UNITED STATES ENVIRONMENTAL PROTECTION AGENCY  
REGION 8

Re: **2017 Sanitary Survey Report**  
**PWS ID#: 083890015**

# 2017 EPA Region 8 TRIBAL SANITARY SURVEY FORM INVENTORY

**Subject:** Bolted steel clearwell (ST02)

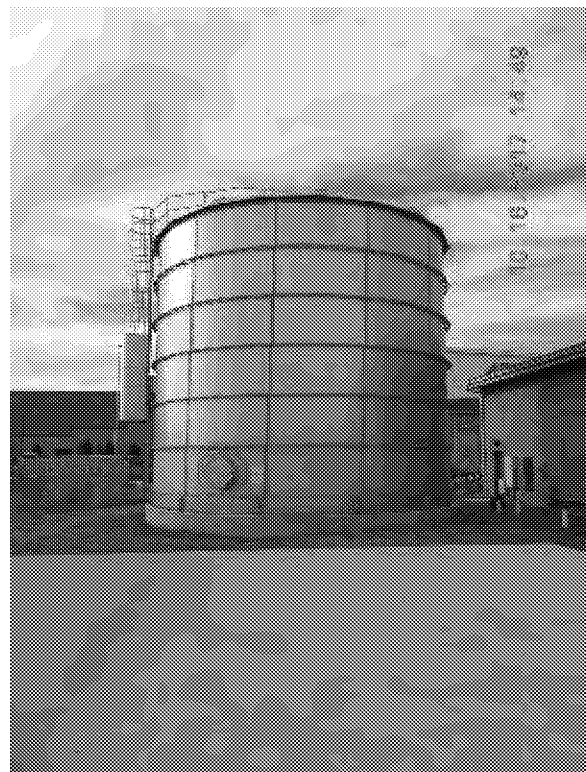
**2) Gravity Tank ID: ST02 - Clearwell, Bolted Steel**

**Unknown integrity of storage tank air vent screen and hatch gasket.**

The sanitary surveyor was unable to evaluate the tank air vent screen and hatch gasket, and the water system was not able to produce documentation of the condition of these components. Each item that could not be inspected during the sanitary survey must be inspected and the structure/condition must be compared to the enclosed **Tech Tips for Finished Water Storage Facilities** to determine if corrective action is needed. Tank inspectors can be third-party professionals or appropriately trained in-house staff.

### **2) Gravity Tank ID: ST02 - Clearwell, Bolted Steel**

**Unknown integrity of storage tank air vent screen and hatch gasket.**

The sanitary surveyor was unable to evaluate the tank air vent screen and hatch gasket, and the water system was not able to produce documentation of the condition of these components. Each item that could not be inspected during the sanitary survey must be inspected and the structure/condition must be compared to the enclosed **Tech Tips for Finished Water Storage Facilities** to determine if corrective action is needed. Tank inspectors can be third-party professionals or appropriately trained in-house staff.

| Complete for all tanks at ground water systems and consecutive systems. Also complete for finished water tanks at surface water / GWUDI systems. (Includes indoor clearwells and contact tanks or other finished water tanks.) |   |   |   |
|--|---|---|---|
| Comments about access hatch:   | Surveyor was unable to view the hatch. Previous survey shows shoebox lid and correct height. Gasket was present during previous survey. | _____   | Hatch info derived from inspection report and photos provided by Kris Neset of the IHS, from inspection performed 9/16/2017 |

- A completed copy of the Unknown Integrity Checklist.
- Labeled photos of each tank rooftop tank component the surveyor was unable to access.
- The date that any corrective actions needed to address deficiencies with the tank components will be completed. EPA will review the integrity checklist and may require additional corrective actions.
- A completed Significant Deficiency Correction Notice listing each individual deficiency and the date of correction.

- A completed copy of the Unknown Integrity Checklist.
- Labeled photos of each tank rooftop tank component the surveyor was unable to access.
- The date that any corrective actions needed to address deficiencies with the tank components will be completed. EPA will review the integrity checklist and may require additional corrective actions.
- A completed Significant Deficiency Correction Notice listing each individual deficiency and the date of correction.
